Darling Square NE Plot

Design Report for Section 96 Application to Modify SSDA7

Prepared for
Lendlease
December 2016

2.1 Internal Amendments - Ground Level Plan

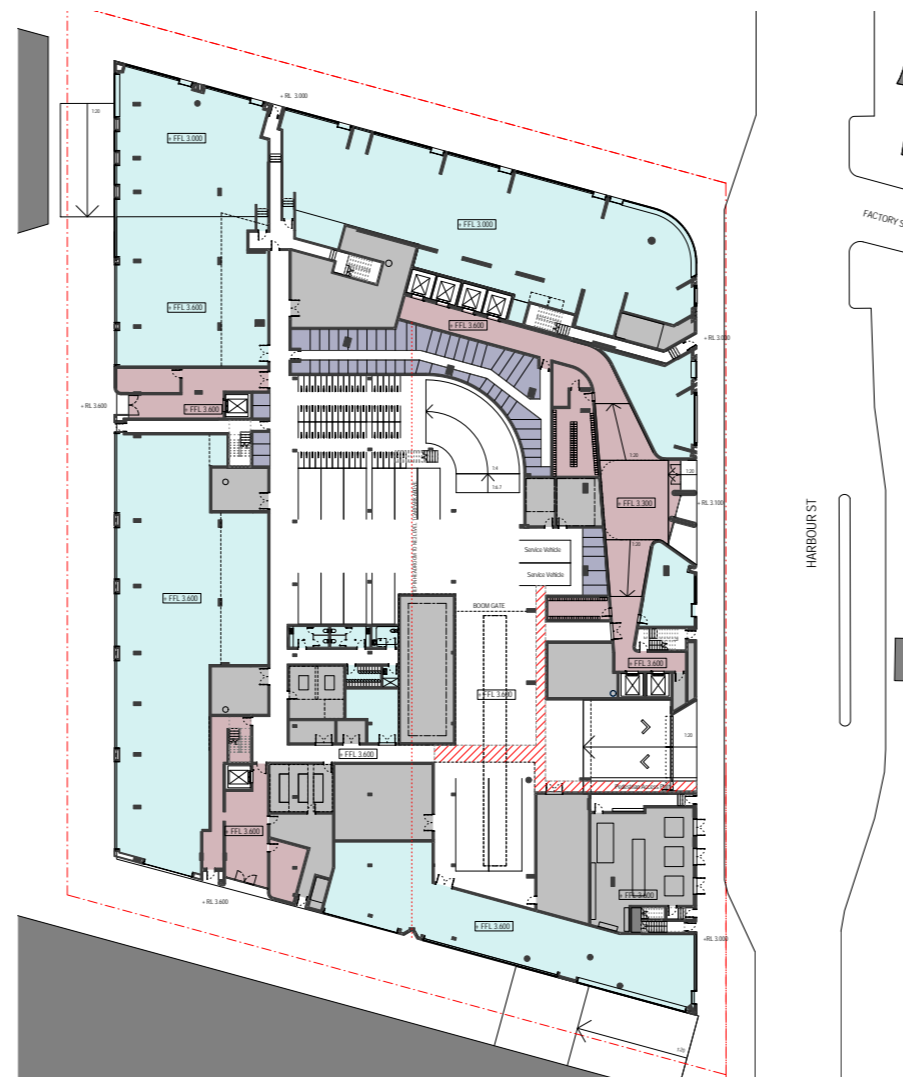
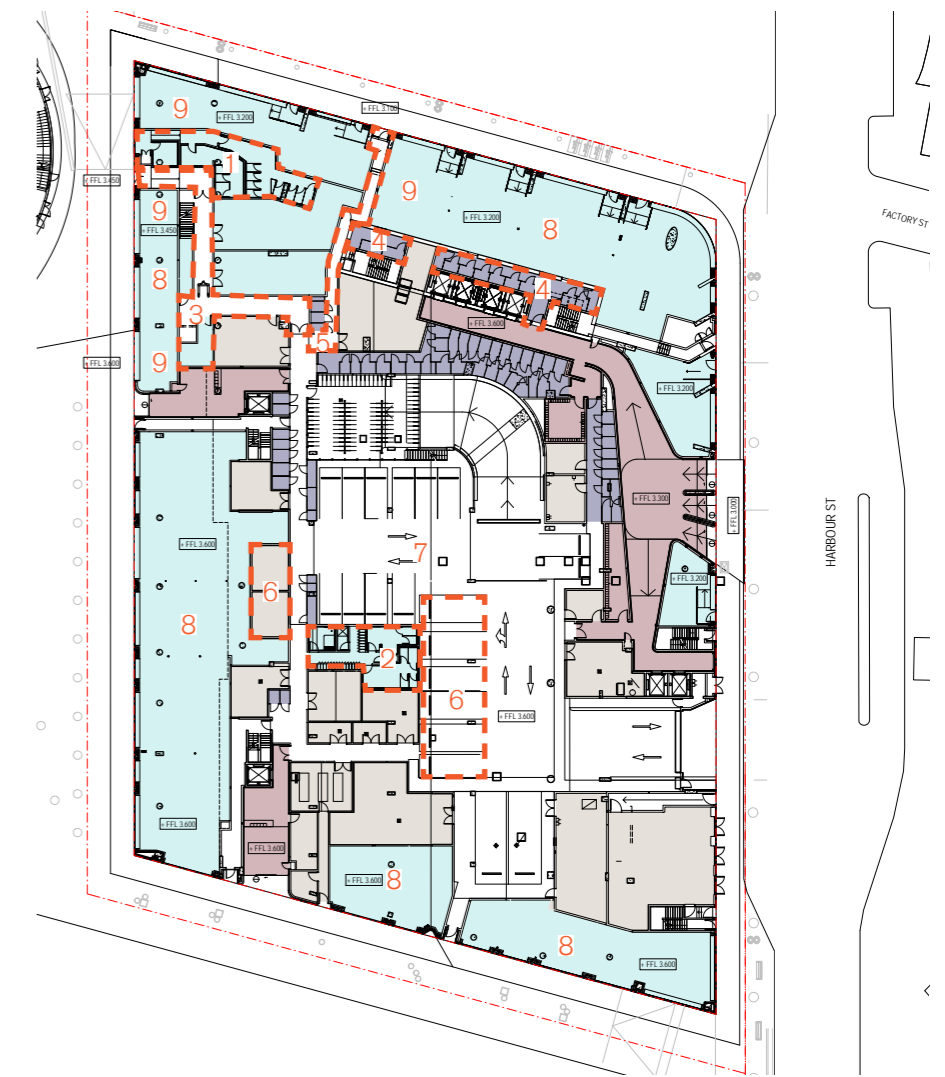
New amenities have been incorporated within the North East Plot ground floor to provide the following:

1. Additional provision of public toilets to support the future operation of NE Plot Retail, N Plot and the Square. Male toilets will have 3 pans and 7 urinals. Female toilets will have 8 pans;

2. Improved BOH facilities for the retail tenancies, inclusive of waste room, cool room, liquor storage and goods hoist;
3. 6 service bays have been provided for loading and unloading to support the North Plot (SSDA10) including the addition of corridor access and 2 existing loading bays amended such that they now service both the North Plot and the NE Plot.

4. Additional storage cage area allocated to optimise space usage and provide easier tenant access;
5. Realignment of egress stair;
6. Relocation of fire tank to provide additional loading bays;

7. General updates to planning resulting from design development;
8. Overall retail GFA reduction from 2050sqm to 1986sqm due to expansion of the BoH supporting N Plot operations

9. Public domain and retail levels have been changed in accordance with the flood mitigation strategy. The transition has been managed internally through ramps installed within applicable tenancies with minor level transitions from the public domain.

2.1 Internal Amendments - Mezzanine Level Plan

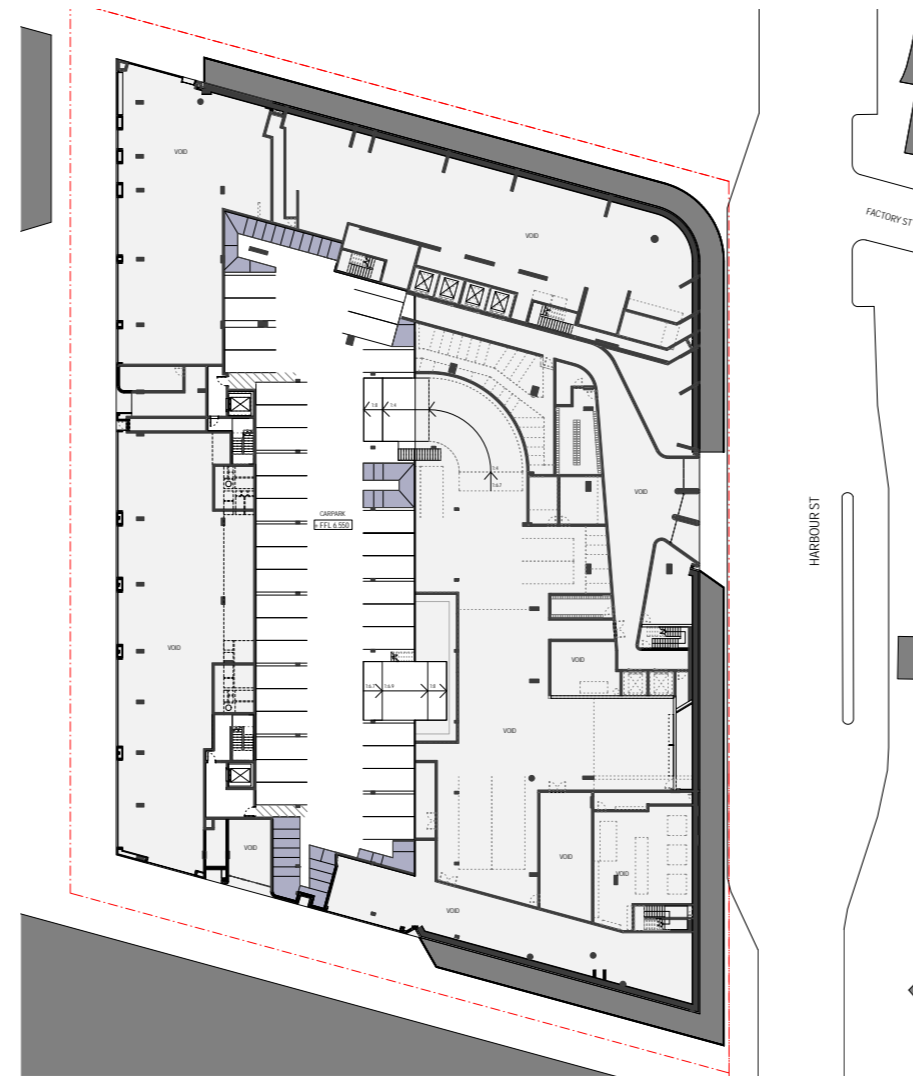
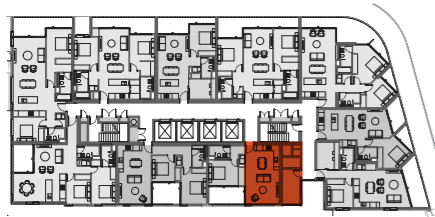
Additional back of house and plant areas inclusive of managers office and dry storage have been added to meet the operational requirements of the retail tenancies in the North Plot (1). Additional storage cage area allocated to optimise space usage and provide easier access (2).

2.2 Internal and External Amendments - Level 34-39 & NE3 South Facade

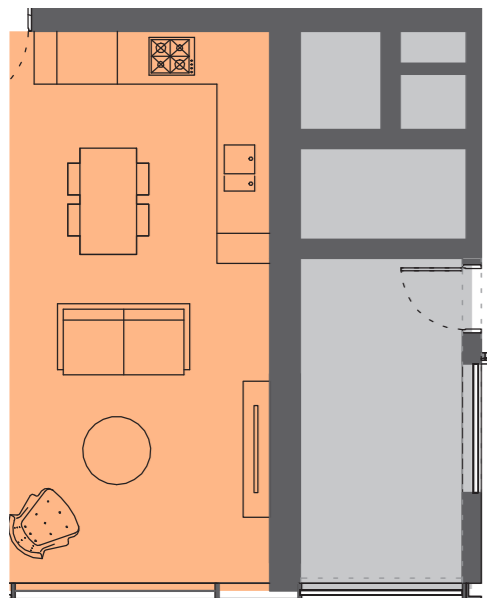
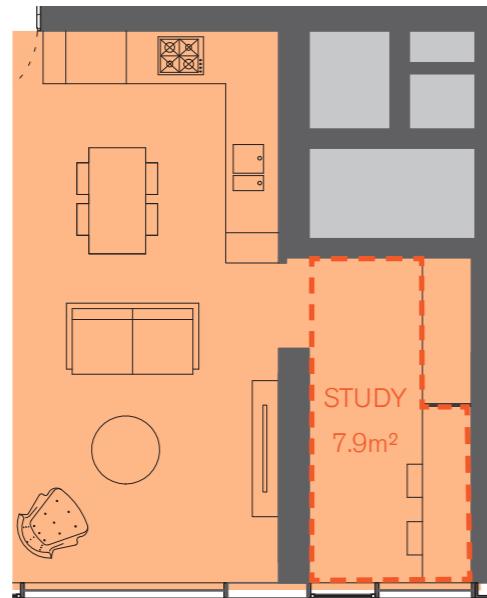
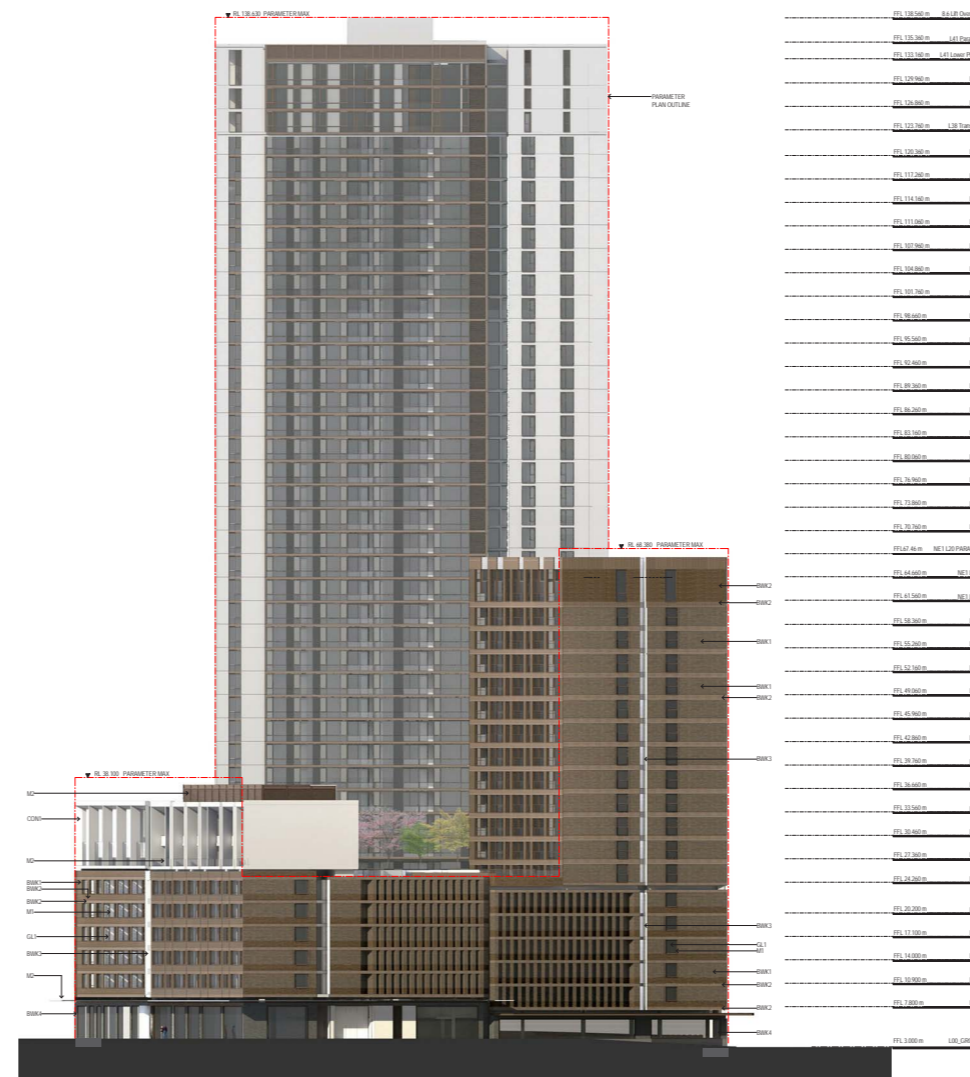
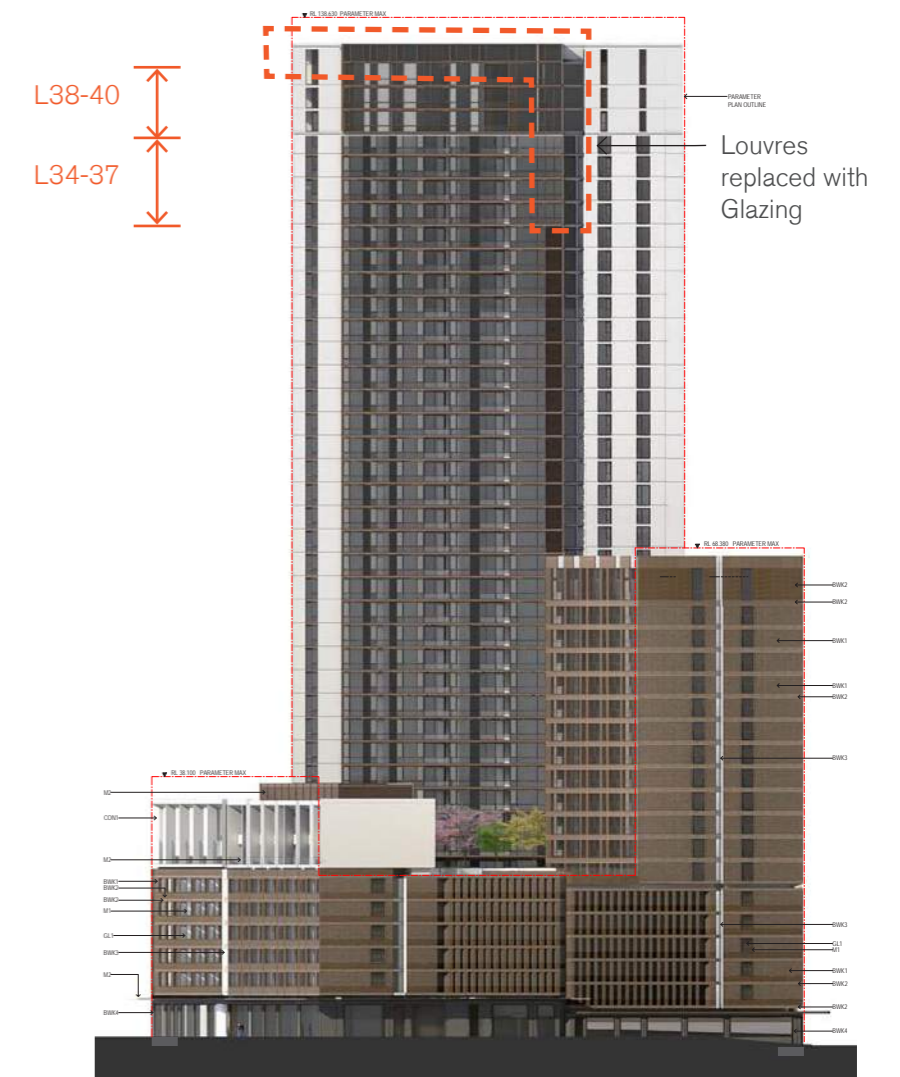
As a result of design development, efficiencies have been identified in the allocation of plant space allowing plant rooms on Level 34 - 37 to be converted to study areas for the adjacent apartments (Refer to Appendix 2 for SEPP65 and ADG compliance summary). The louvres have therefore been replaced with glazing to provide the required amenity to these rooms. In addition, the redundant louvres to the roof plant have been replaced with opaque glass, consistent with the facade glazing system. Refer to the Development Summary in the appendices for resulting changes to the GFA.

As a result of the amendments, the glazing has been extended to L38-40 for consistency in the facade detailing.

2.2 Internal and External Amendments - Level 40 and NE3 North Elevation

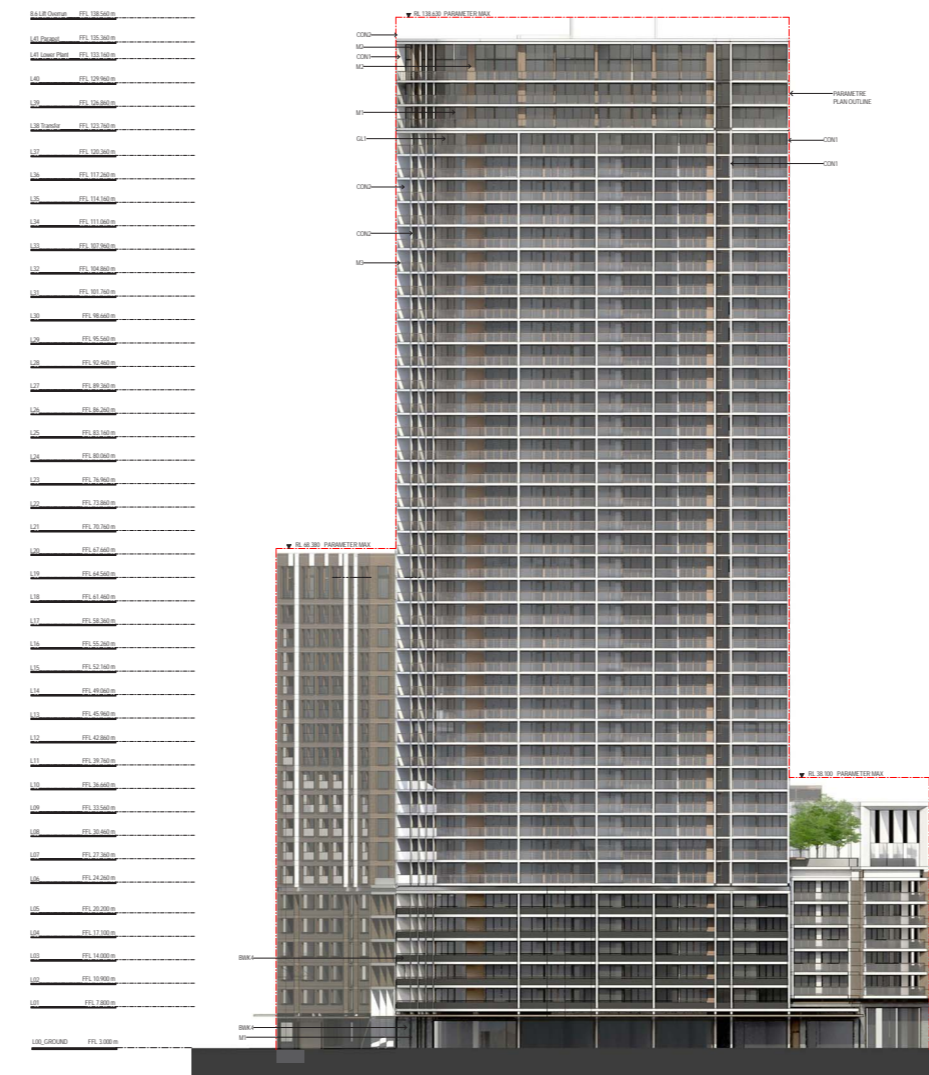
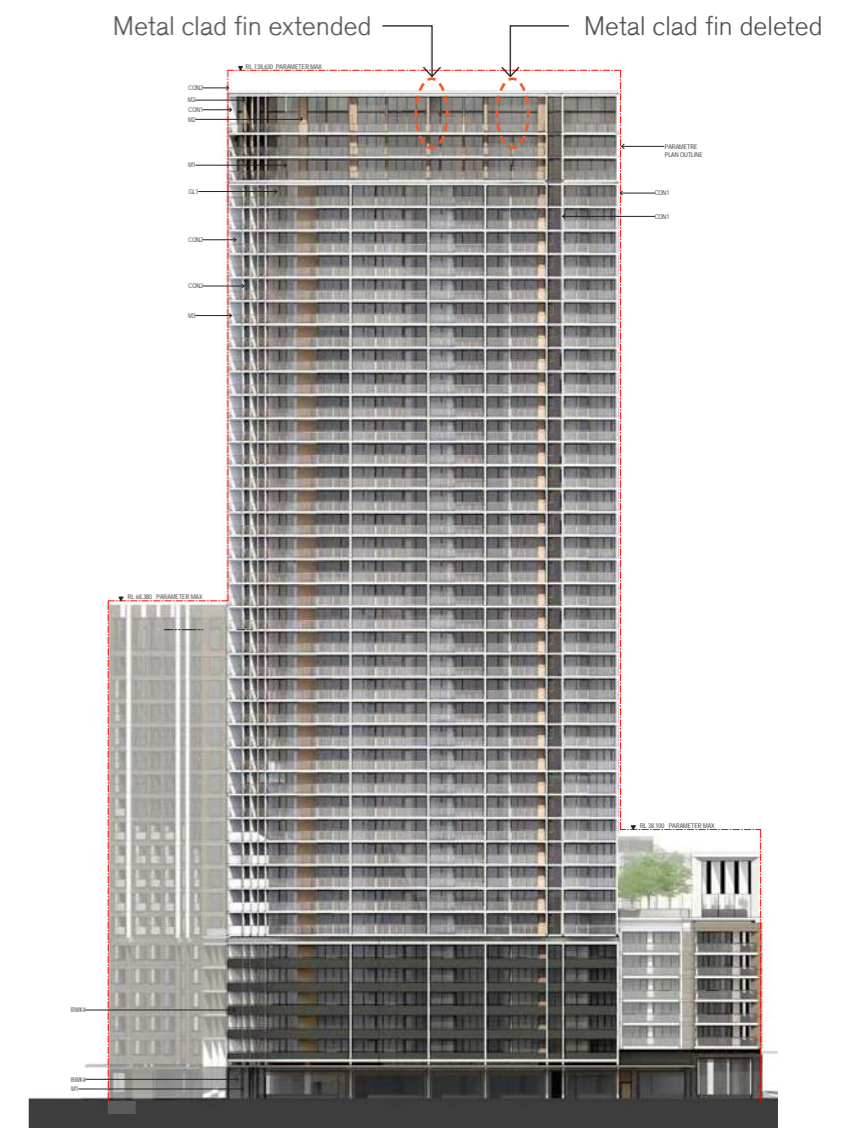
The apartments on Level 40 have been reduced from 6 (2 x 4bed, 2 x 3bed, 2 x 2 bed) to 2 (1 x 5 bed, 1 x 4 bed) following discussions with prospective purchasers. This has resulted in internal layout amendments and a slight modification to the detailing of the dividing balcony walls whilst maintaining the alignment and vertical rhythm of the tower facade. Refer to appendices for SEPP65 and ADG Compliance Summary.

2.2 Internal and External Amendments - NE3 West Elevation

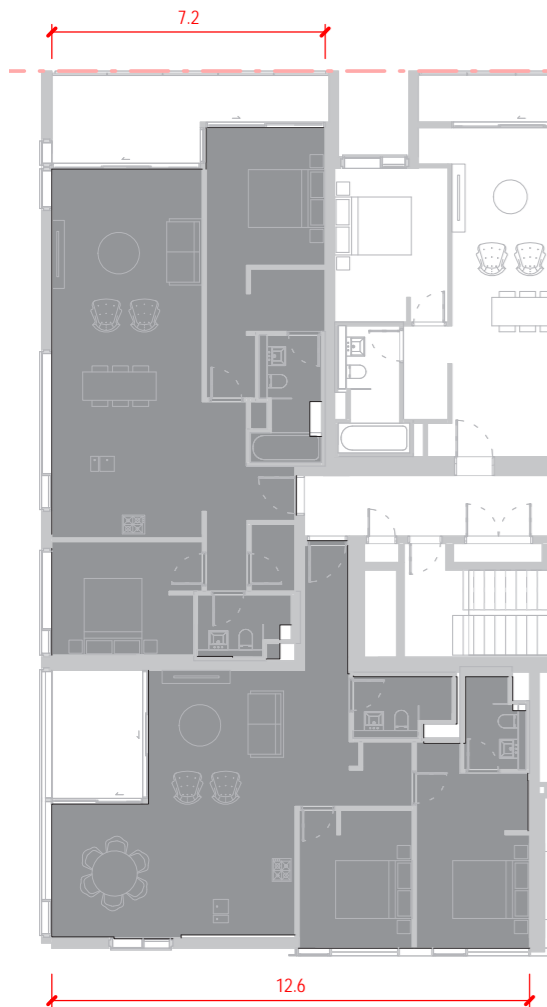
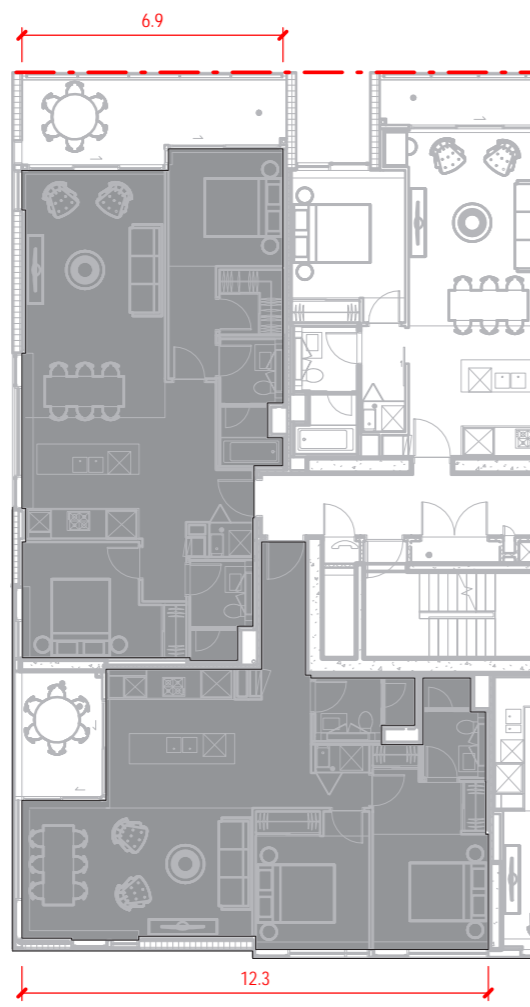
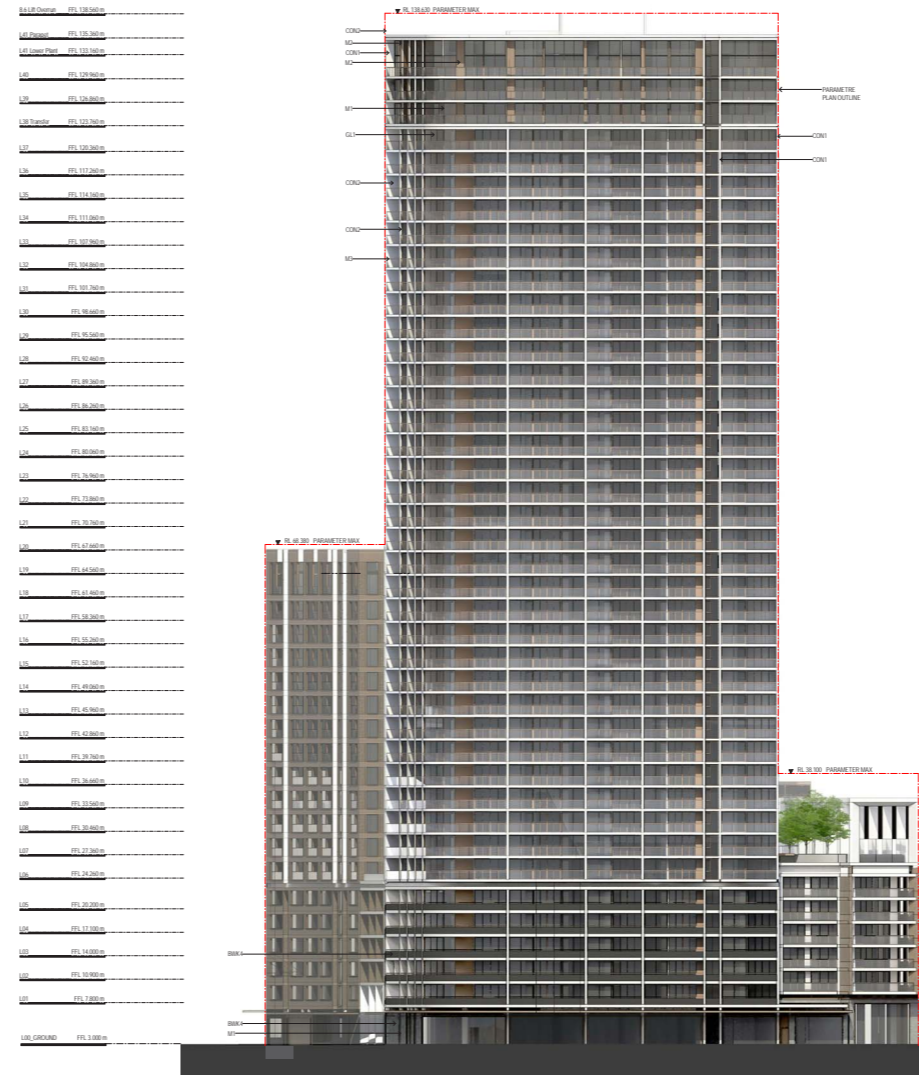
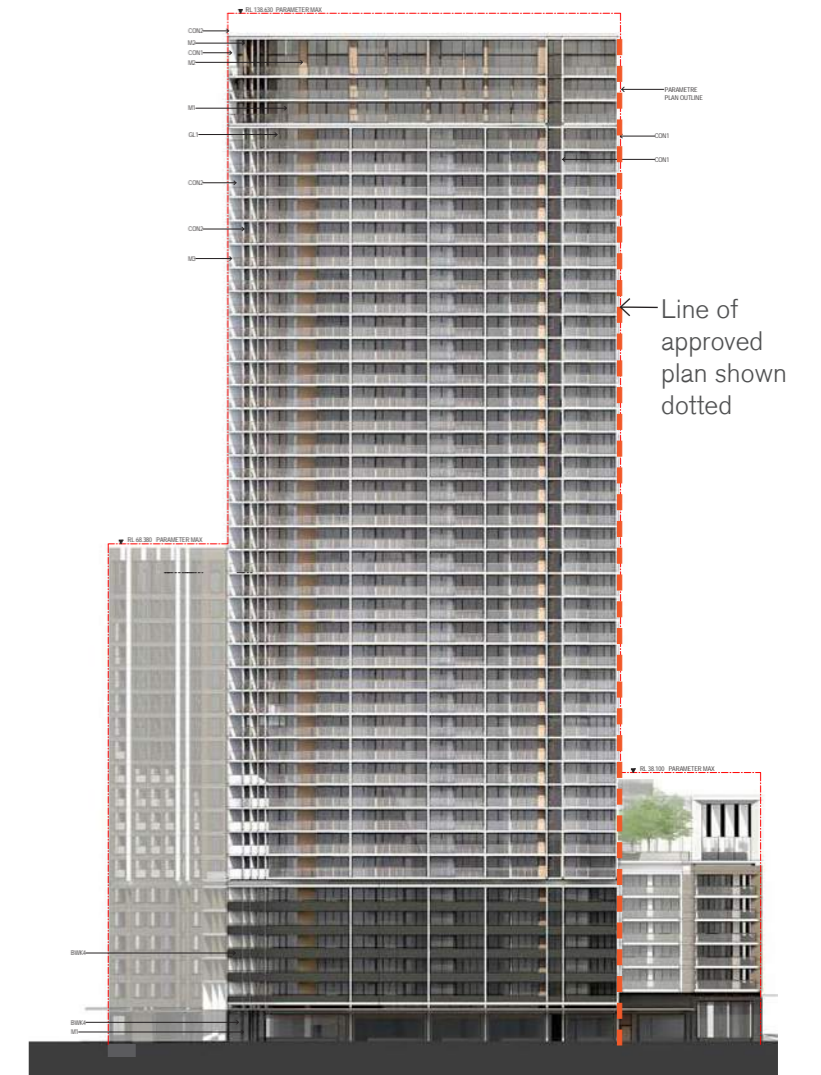
The NE3 tower floor plate has been reduced in width by 300mm by moving the western tower facade east. This is due to the optimization in planning of the two western apartments. This applies on floors L06 to L37. This reduction also resulted in slight amendments to the planning on upper levels L38-L40. Refer Appendices 3.1 - Development Summary and 3.2 - SEPP65 and ADG Compliance.
